Credit Procedure: Reimbursement of Oil Pump for Screamin' Eagle Stage III or IV Kits Registered to SWR

Bulletin number M1450 must be entered into the comments section of the claim.

Figure 1. Cam Support Plate Tightening Sequence

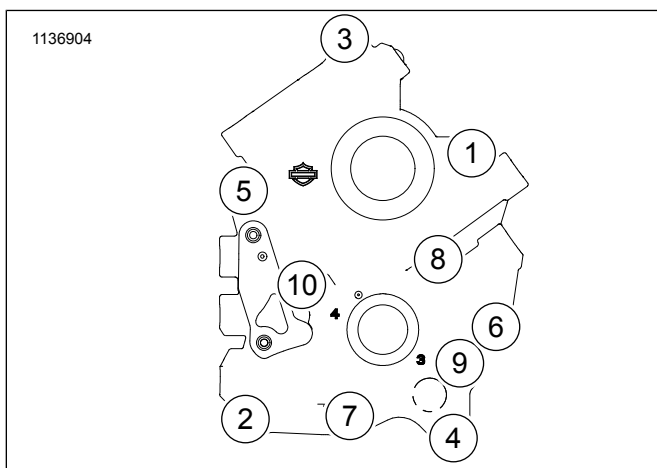
- 1. Install cam support plate. See the service manual.
- 2. Refer to Figure 1. Follow modified tightening sequence.
Torque: 10.4–12.7 N·m (92–112 **in-lbs**)
 - a. Tighten screws 1-6.
 - b. Rotate crankshaft 360°.
 - c. Tighten screws 7-10.
